CENTRAL OTAGO DISTRICT COUNCIL
REPORT OF PLANNING CONSULTANT

APPLICATION	RC250077
APPLICANT	Awa Koura Mining Limited
ADDRESS	Luggate-Cromwell Road (State Highway 6), Cromwell
LEGAL DESCRIPTION	Lot 1 DP 466676, Record of Title 623528
ACTIVITY DESCRIPTION	Alluvial Gold Mine
ACTIVITY STATUS	Discretionary

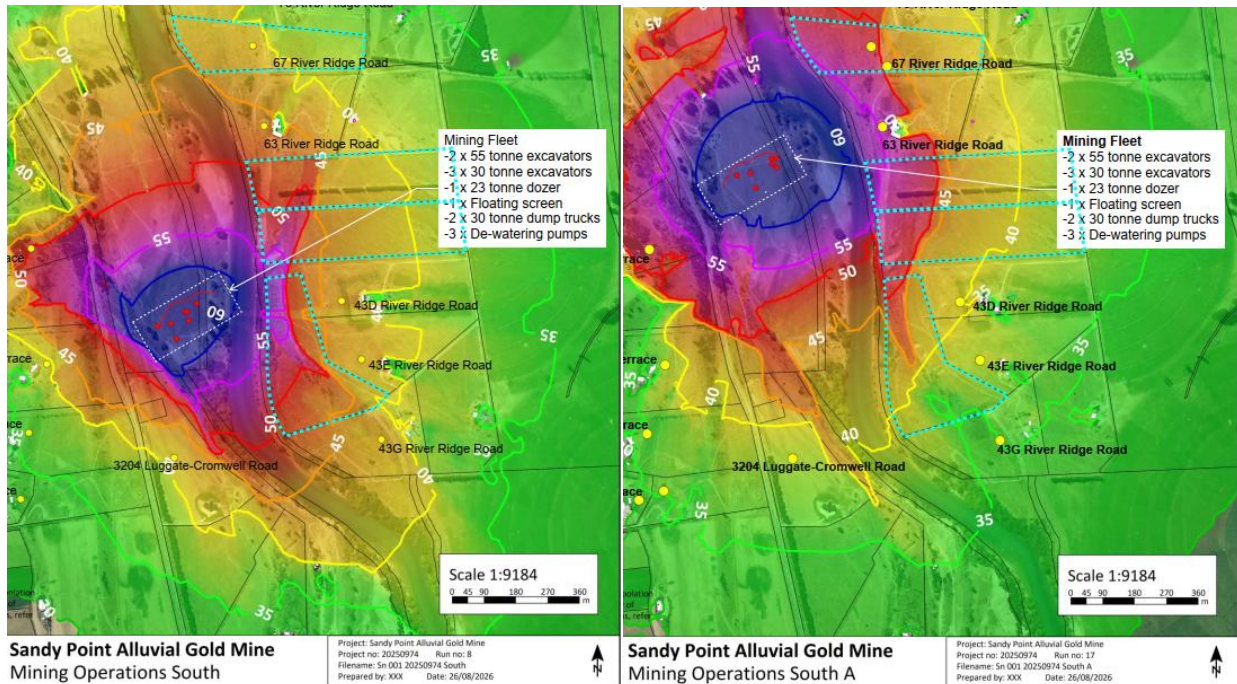
I consider that the receivers at the southern and northern ends of the Proposal may receive noise levels that approach the noise standards for permitted activities, but these will generally be over a short period. Assuming relatively linear progress of the mining, the worst of the effects at these receivers would likely last less than 12 months.

The receivers generally east and west of the central portion of the mining area are likely to receive the highest noise levels and for the longest duration. There are some variations, but it appears to me that assuming a linear mining progression, the central receivers may experience higher noise levels for more than a year and potentially up to two years.

Figure 1. Location of sensitive receptors surrounding the site. *Reproduced from the WSP report.*

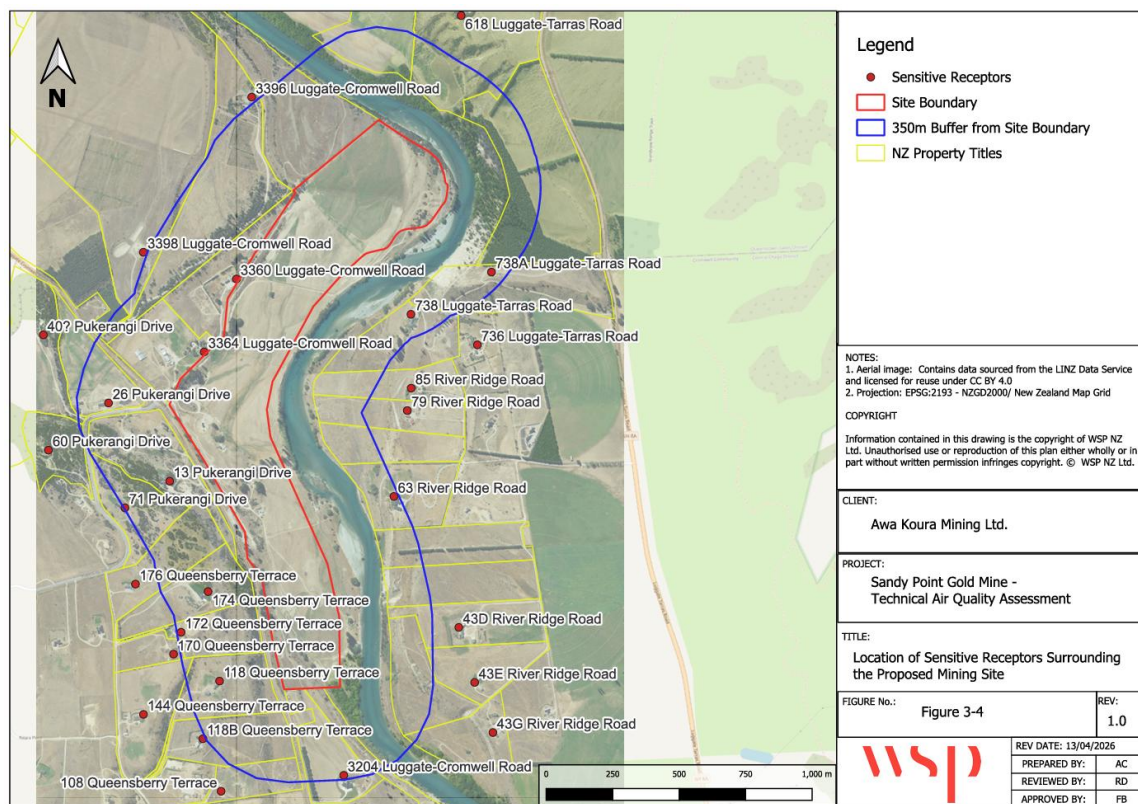
The dwellings at 3360 and 3364 Luggate-Cromwell Road are immediately adjacent to the site boundary. AKML has stated that the 3364 Luggate-Cromwell Road is owned by K Landreth who will undertake the subdivision of the site following mining and therefore considers that approval of the mining application is implicit. The owners of 3360 Luggate-Cromwell Road have not submitted on the application and have not provided written approval. The dwelling on this property is approximately 10m from the site boundary.
